CITY OF ALBUQUERQUE

A & S Autocare

Traffic Circulation Layout

Engineer's/Architect's Stamp 01-15-2020 (F15D054)

TRAFFIC CIRCULATION LAYOUT

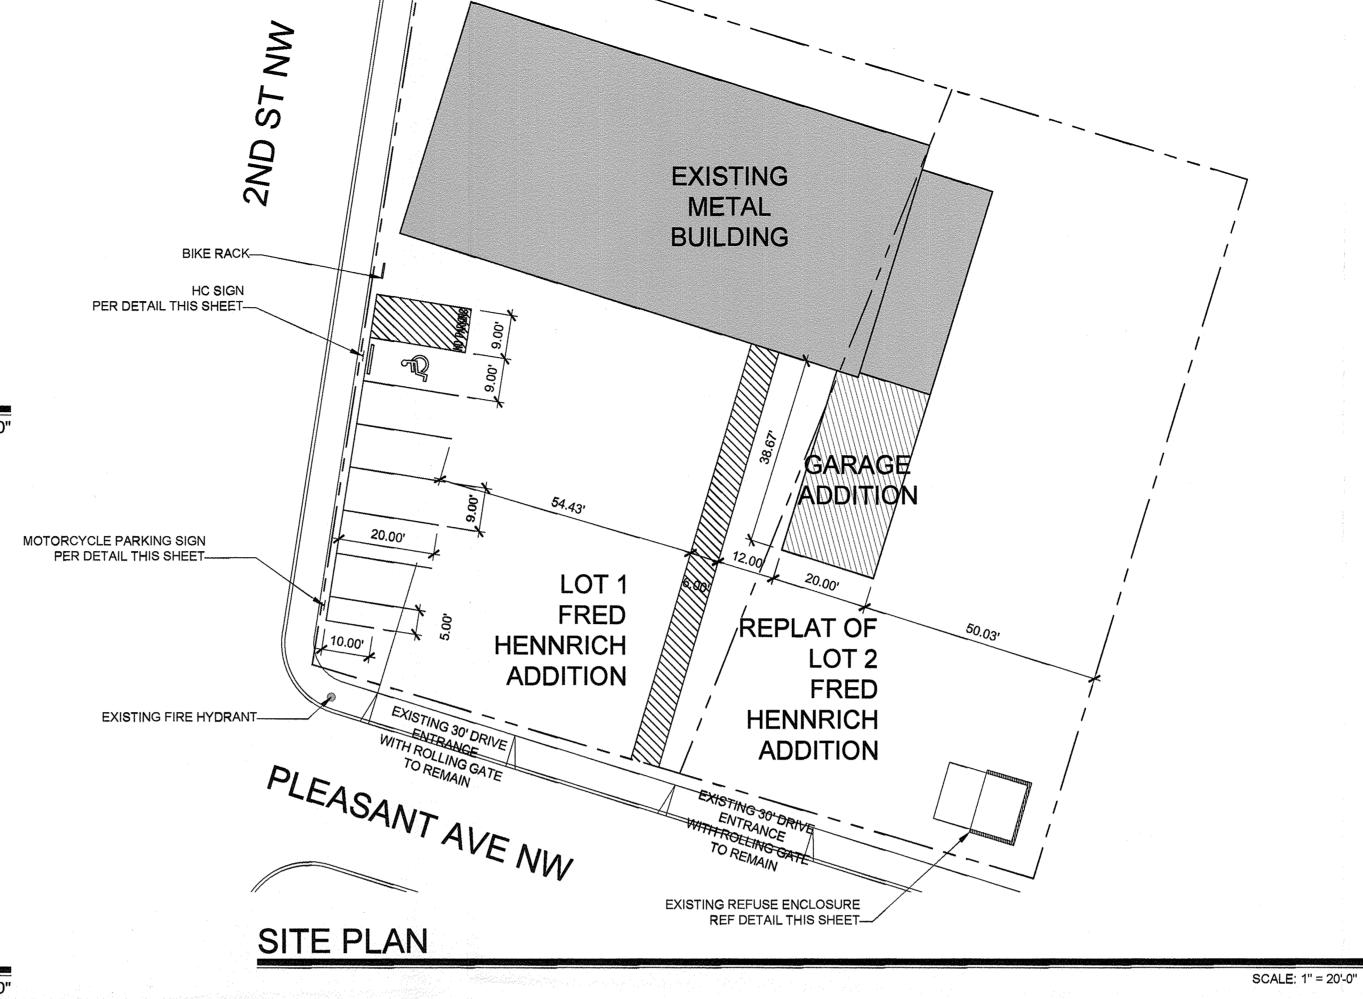
- 1. It seems like the lot line won't be eliminated. In that case, please provide a shared access agreement.
- 2. Any unused curb-cut needs to be closed. And there is one on 2nd street.
